**BELL BEND NUCLEAR POWER PLANT  
BBNPP PLOT PLAN CHANGE  
COLA SUPPLEMENT, PART 3 (ER); SECTION 2.7.7 AND  
COLA SUPPLEMENT, PART 11L (NOISE STUDIES)  
BNP-2010-320 Docket No. 52-039**

Revised BBNPP COLA Part 3 (ER), Section 2.7.7, Revision 2b

Revised BBNPP COLA Part 11L (Noise Studies), Revision 2b,  
"2010 Baseline Environmental Noise Survey, Supplement to HAI Reports 041808-1 & 06608-1,  
Bell Bend Nuclear Power Plant (BBNPP)"

**Title:** 2010 BASELINE ENVIRONMENTAL NOISE SURVEY,  
SUPPLEMENT TO HAI REPORTS 041808-1 & 062608-1

Figure 2.7-97— Baseline BBNPP Leaf-Off Sound Survey Measurement Locations

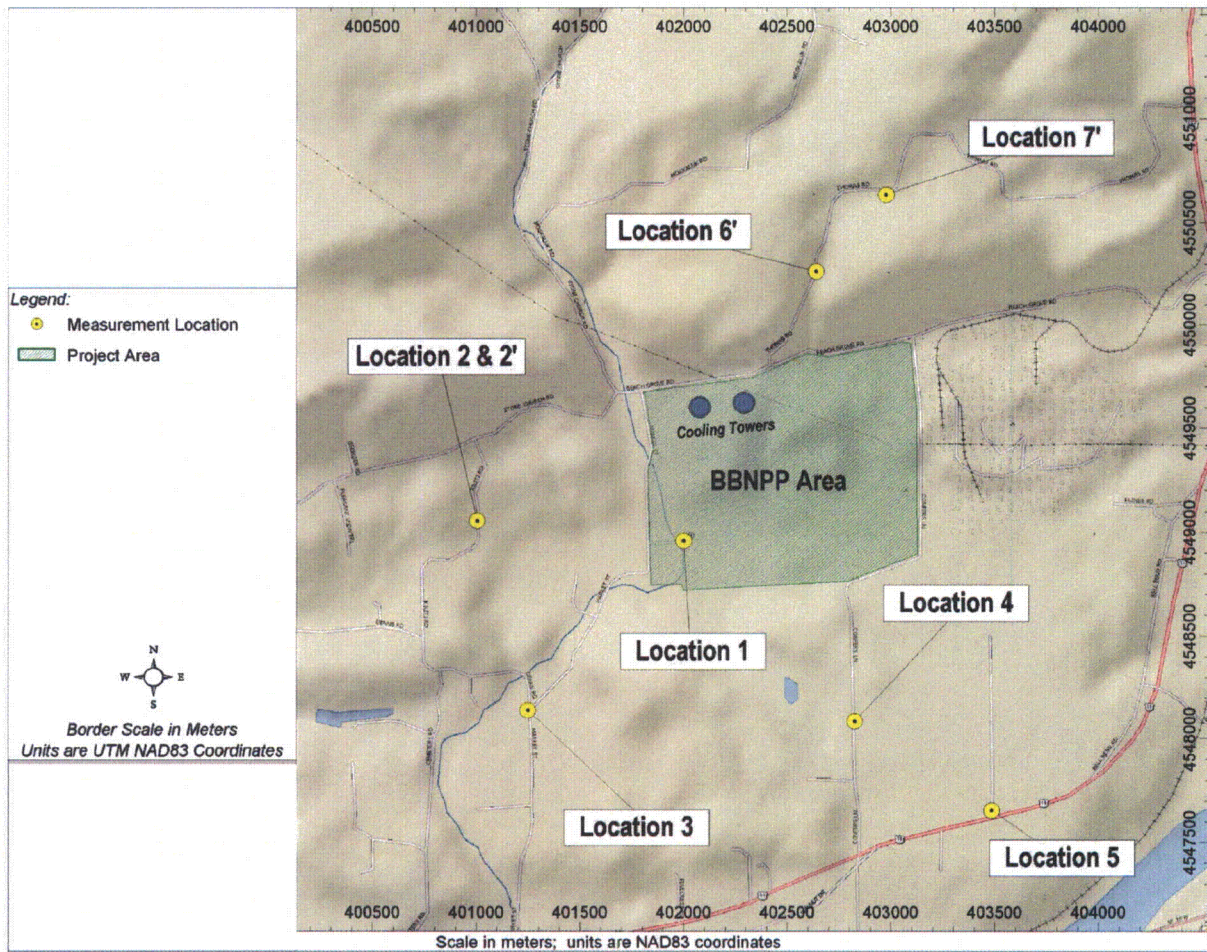
~~Figure 2.7-97~~ Figure 2.7-97 shows the location of the ~~five~~ seven monitoring sites. Monitor location 1 was in the planned BBNPP plant area reasonably close to the existing SSES Units 1 and 2. Locations 2, 3 and 4 are at the closest residential receptors. Location 5 is on the power line right of way approximately 200 feet from U.S. Route 11. Locations 6 and 7 represent areas north and northwest of the BBNPP plant area and associated cooling towers. The closest potentially sensitive receptors represent existing conditions and can be used to assess potential noise impacts from the new plant.

Figure 2.7-98— Measured Hourly Residual (L90) Sound Levels at Survey

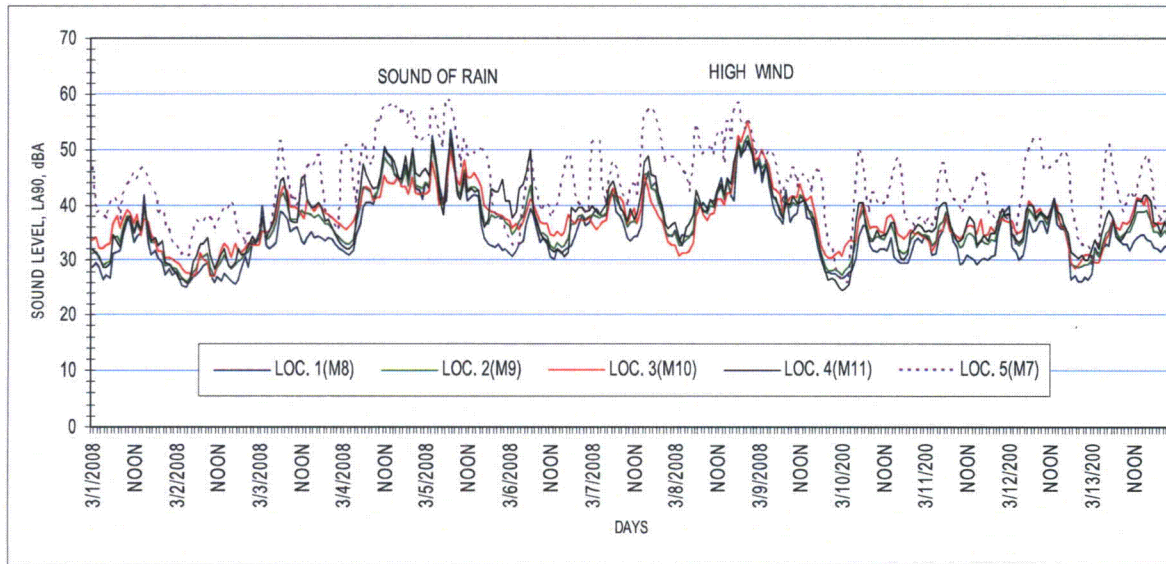
~~Figure 2.7-98~~ **Figure 2.7-98** plots the hourly residual (L90) sound levels at the residential locations for the survey period. Specifically, the minimum hourly residual LA<sub>90</sub> sound levels at the residential locations for the survey period are plotted. The plot illustrates consistent trends in the five community locations except at location 5 (dotted line) that contains nearly constant noise from U.S. Route 11 only 200 ft (61 m) away. The levels for location 2 are calculated from the average of results at locations 1, 3 and 4. The residual ambient is essentially constant for all practical purposes at any of the locations 1, 3 and 4. This occurs in areas where the environmental sound sources are far off in distance relative to the distance between monitoring points and the natural sources are similar at all locations. The sound of rain and high wind are indicated on the plot. The major source of environmental noise in the project area is from far-off unidentifiable traffic. Absolutely no sounds were detectable during attended measurement for normal operation on February 29, 2008. SSES Unit 1 was shut down on March 3, 2008. Noise from the plant, presumed to be construction or maintenance sources, was readily audible during the March 14, 2008 attended measurement survey. Therefore, in the absence of construction and maintenance activities, all measured ambient sound levels can be attributed to normal, current environmental sources, such as traffic noise, high wind and rain and are not related to the existing SSES Units 1 and 2 plant.
